REQUEST

Current Zoning: R-3 (single family residential)
Proposed Zoning: I-1(CD) (light industrial, conditional) and
MUDD(CD) (mixed use development, conditional)

SUMMARY OF PETITION

The petition proposes to allow a mixed-use development on vacant land located in Southwest Charlotte, near Berewick and Charlotte Premium Outlets.

• **Proposed Request Details**

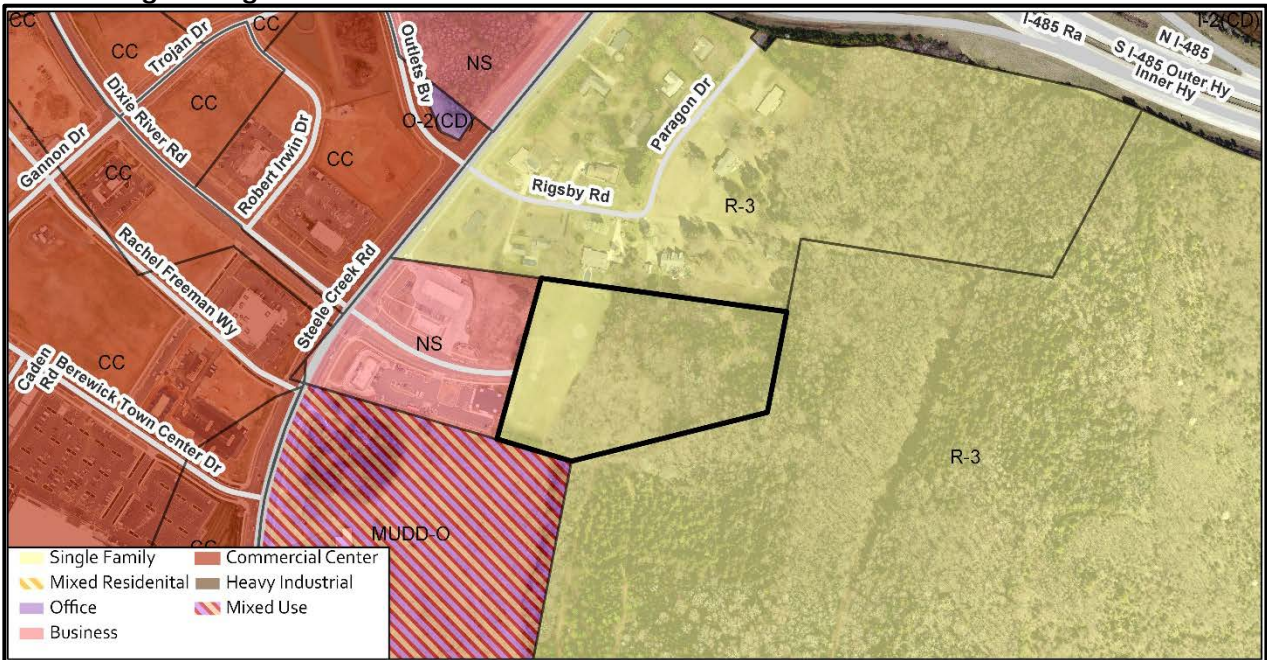
- ~~1. Update the site plan conditional note(s) to commit to install 25 mile-per-hour MUTCD signs on the new public streets.~~ Addressed

- ~~2. MUDD areas will be required to provide 15% tree save area onsite. Show tree save area on site map. Tree save area must be 30 feet minimum width. Must contain existing healthy trees.~~ Addressed
